ADDENDUM NO. 1 TO BID NO. 13-0107-4

FOR: CLOVERDALE COMMUNITY CENTER

PLEASE SEE THE FOLLOWING FOR ADDITIONS, CLARIFICATIONS AND/OR CHANGES:

B
P-2
WATER RISER DIAGRAM
SCALE : NTS

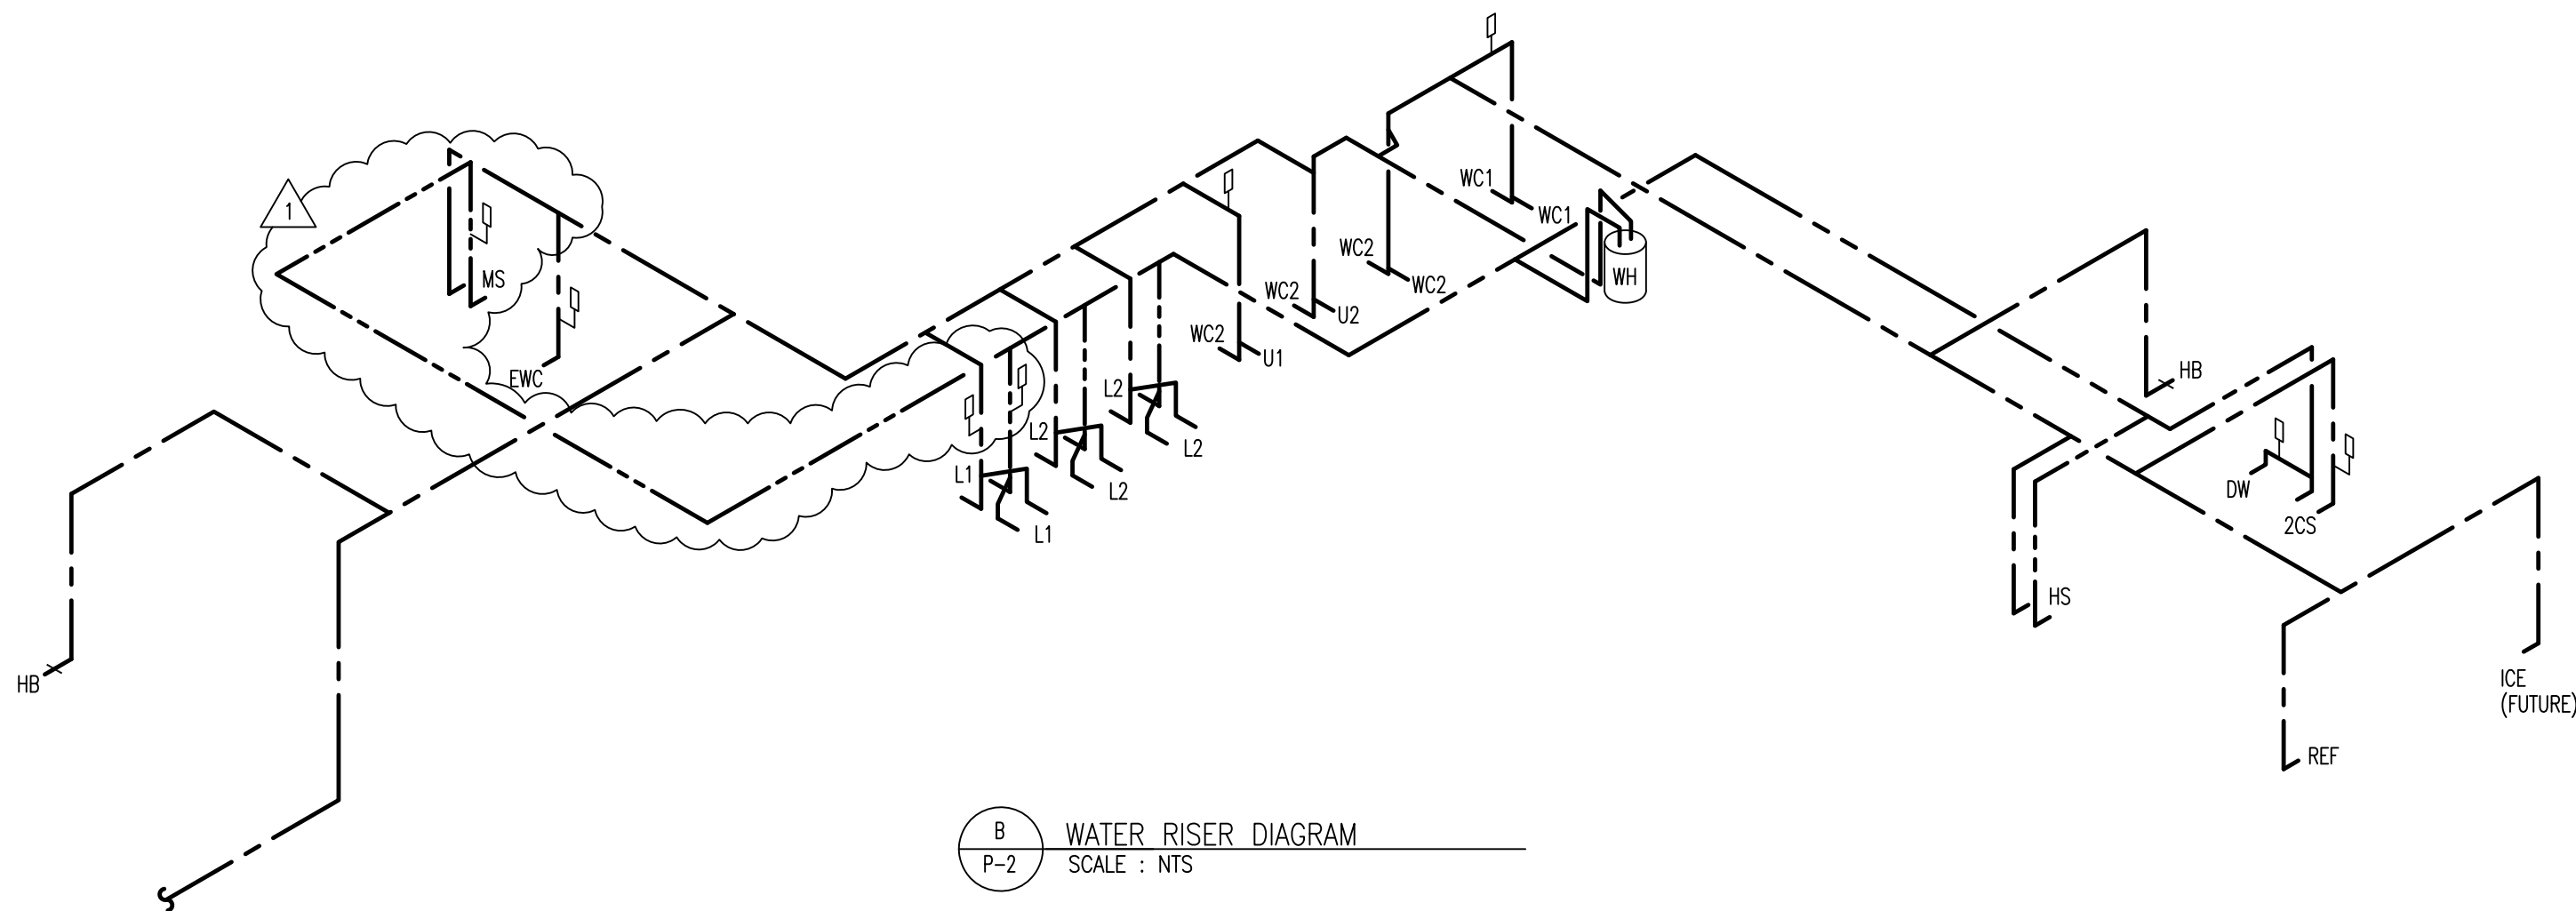
SHEET P-2

Water Riser Diagram

Change “2CS to read “3CS”.
